(This Service Bulletin is FAA D.O. Authorization SW-1 Approved)

SUBJECT: Addition of Drain Holes in the M20F Rudder

MODELS AFFECTED: M20F S/N 660003, 660004, 670001 thru 670303 with the exception of the following serial numbers: 670139, 670201, 670246, 670255, 670257, 670258, 670268, 670271, 670273, 670276, 670277, 670279, 670284, 670285, 670286, 670289, 670290, 670293, 670295.

FIGURE 1.

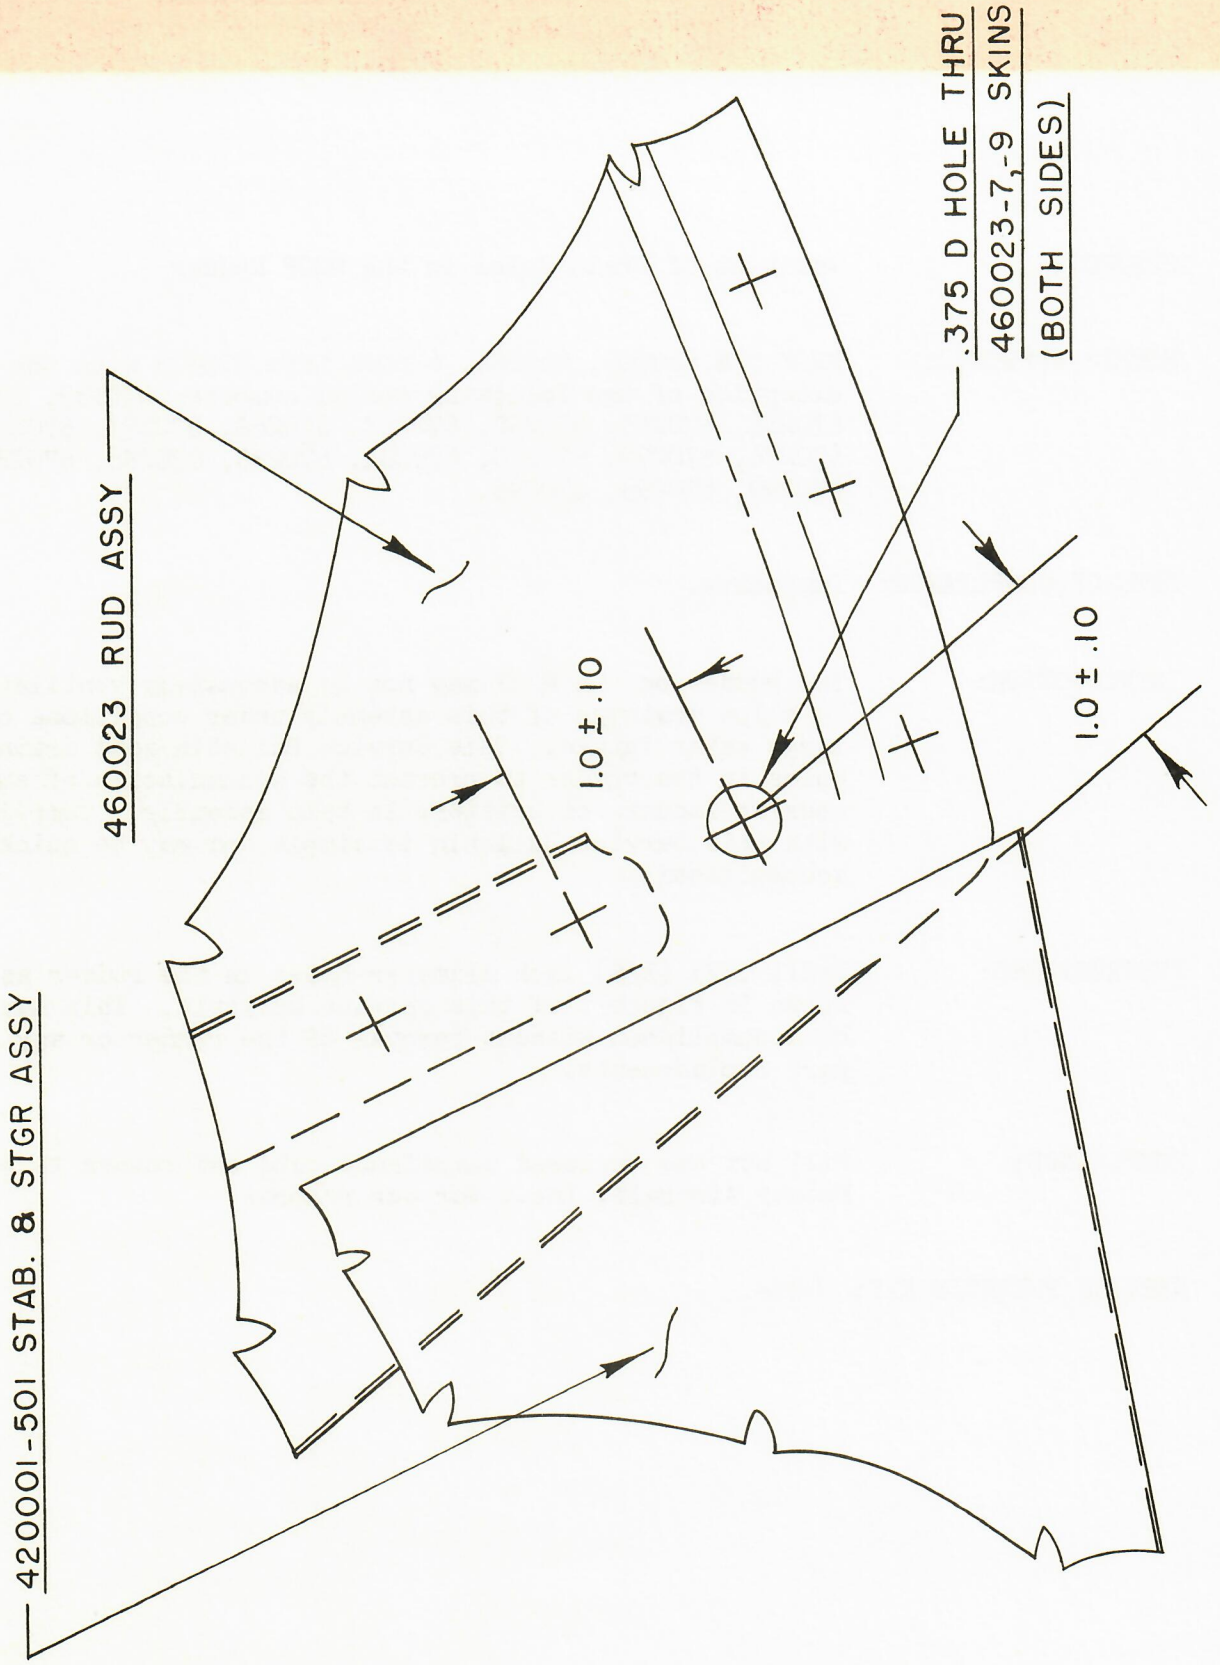
INTRODUCTION: The rudder on the M20F may not be adequately ventilated to allow drainage of this assembly under conditions of large water intake. This Service Bulletin adds drain holes in the rudder to prevent the accumulation of excessive amounts of moisture in this assembly. Compliance with this Service Bulletin is simple and may be quickly accomplished.

INSTRUCTIONS: Drill .375 (3/8) inch diameter holes in the rudder as shown in Figure 1 of this Service Bulletin. This may be accomplished without removal of the rudder or any part replacements.
